Maryland
Department of
the Environment

Overview of Mountain Christian Church Drainfield System

History of Septic System Evaluation and State Groundwater Discharge Permit

Locations of Soil Test Pits Evaluated in 1998 and 2002

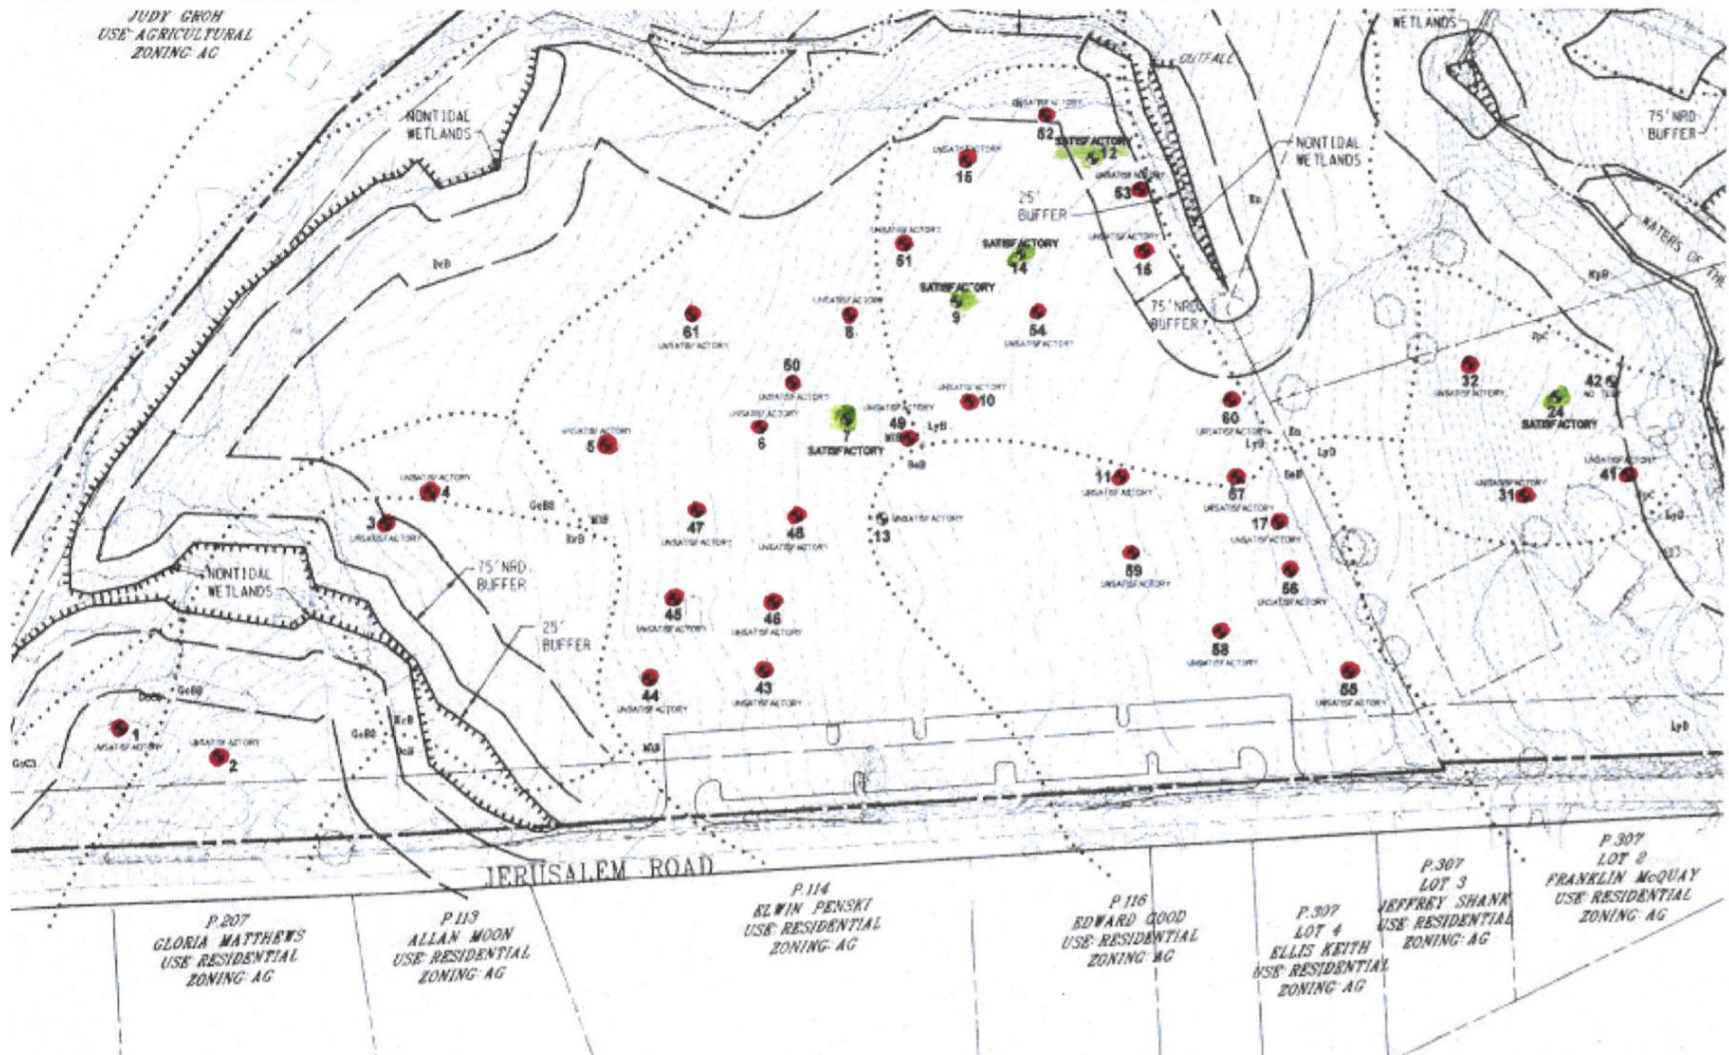
1. Harford County Environmental Health Department evaluated soil test pits along Route 152 and Jerusalem Road in 1998 and again in 2002.
2. At that time, 18 test pits were thought to involve “satisfactory” soil and groundwater characteristics for drainfield system installation, 54 test pits were considered in the “unsatisfactory” category.
3. A sand mound system repair is not considered possible at this site since it requires a much larger surface area and uses a much lower loading rate than the 1.2 gal/day/sq ft loading rate used for the existing trench system design.
4. One area with four “satisfactory” test pits (No. 76, 77, 78 and 79) close together was selected as the current drainfield site.

Locations of Existing Drainfield Site and Soil Test Pits

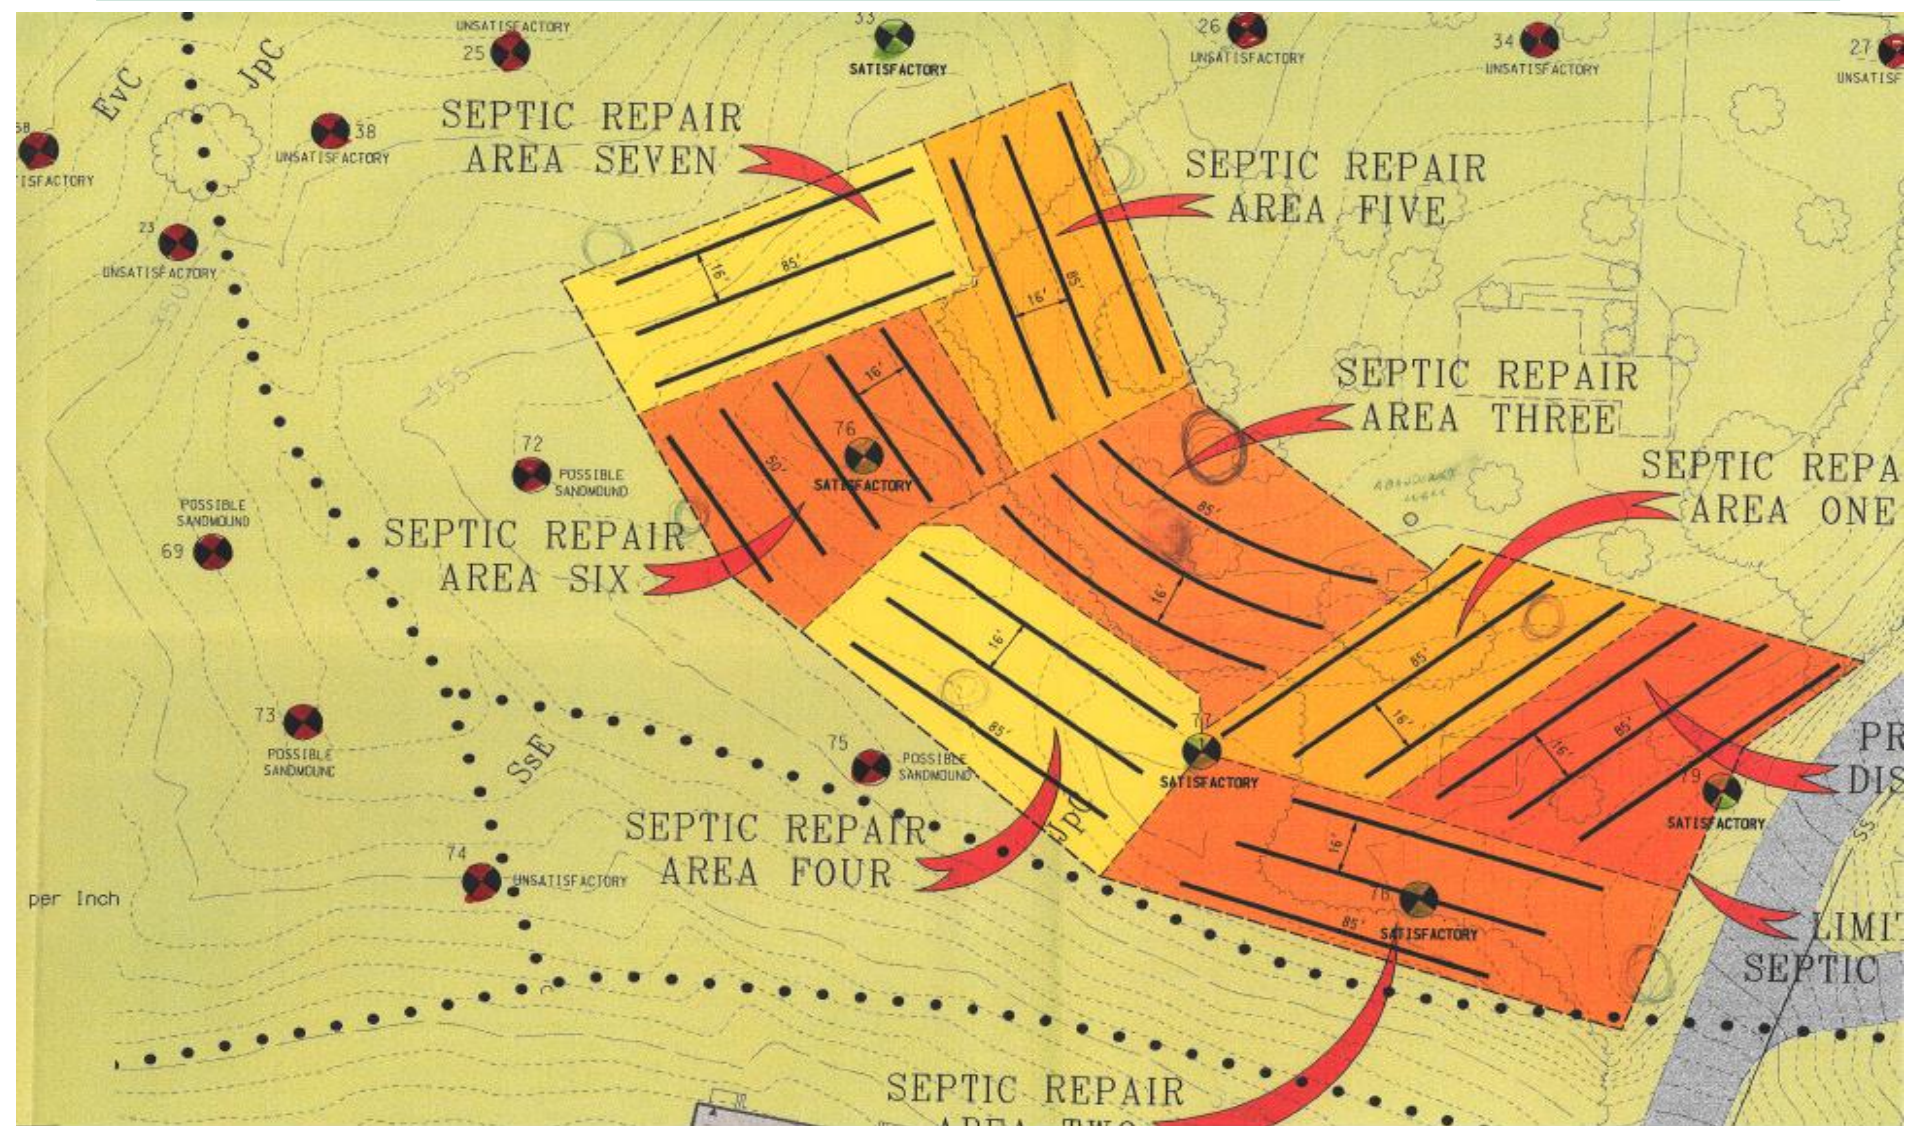
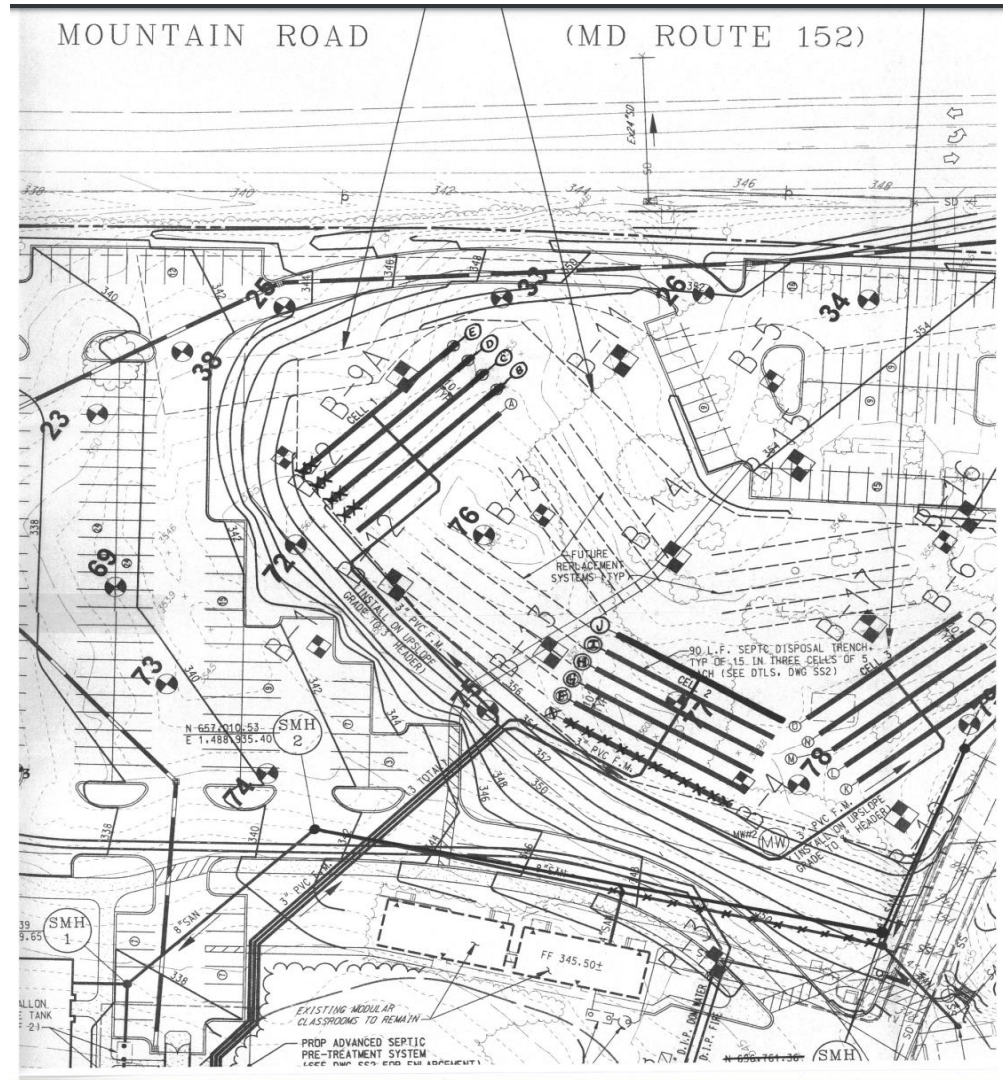
1. Although the drainfield is located in an area labeled as satisfactory soil testing in 2002, it is surrounded by unsatisfactory soil with clayey soil at shallow depth.
2. The “satisfactory” soil in the existing drainfield is likely impacted by a clay bottom as shallow as 13 ft (TP 76).
3. The soil in the existing drainfield and the nearby unsatisfactory soil form a clay bowl with the potential to accumulate effluent and cause overflow or seepage.
4. To date, two septic systems installed in the past at the Mountain Christian Church have failed (2003 and now) due to impermeable soil.
